Addendum 128 – UN Regulation No. 129

Revision 4 - Amendment 4

Supplement 4 to the 03 series of amendments – Date of entry into force: 3 January 2021

Uniform provisions concerning the approval of Enhanced Child Restraint Systems used on board of motor vehicles (ECRS)

Figure 2

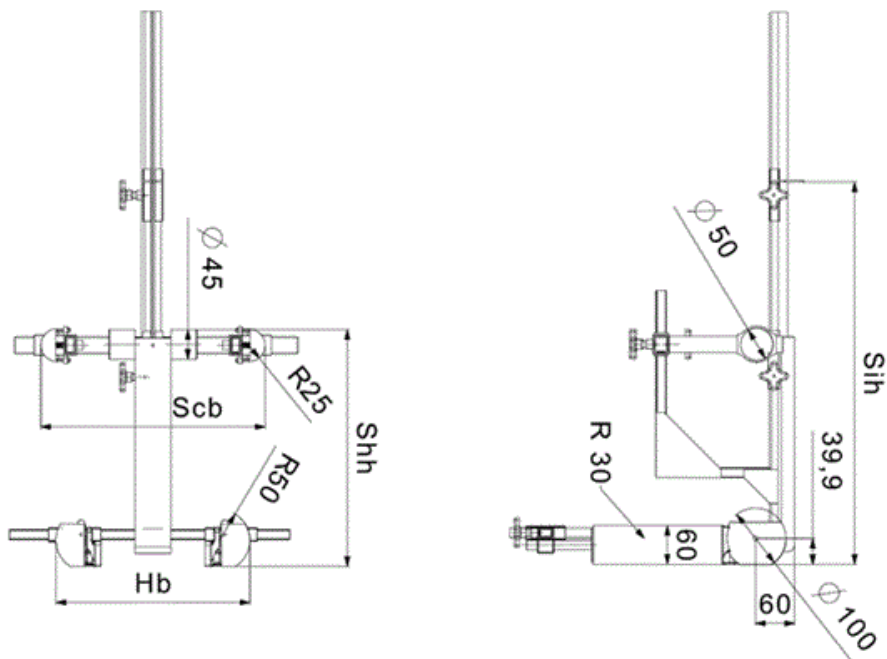
Annex 18., amend to read:

ECRS Measurement Device - Side and Front View of the measuring device

For integral or non-integral ECRS the device shown in Annex 18, Figure 2 shall be used.

The mass of the devices described in Figure 2 and Figure 3 shall be 10 kg +/- 1 kg.

All measurements shall be taken with the device base in contact with the seat pan of the ECRS and the device backrest in contact with the backrest of the ECRS. All lateral dimensions shall be measured under a contact force of 50 N with the devices described in Figure 2 and Figure 3 of this annex.

Figure 3

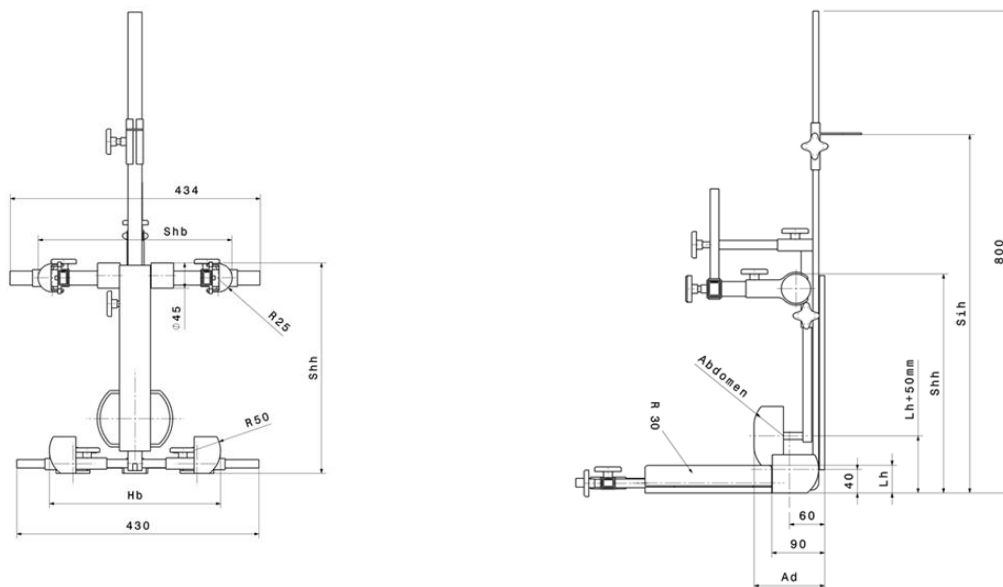
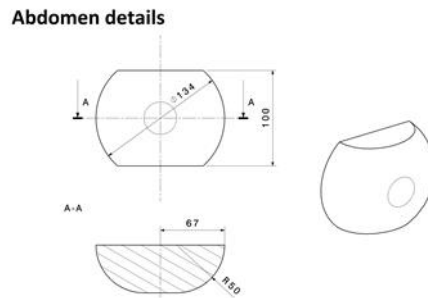
Side and Front View of the measuring device for measurements applicable to Enhanced Child Restraint Systems that feature an impact shield

For ECRS with an impact shield the device shown in Annex 18, Figure 3 shall be used.
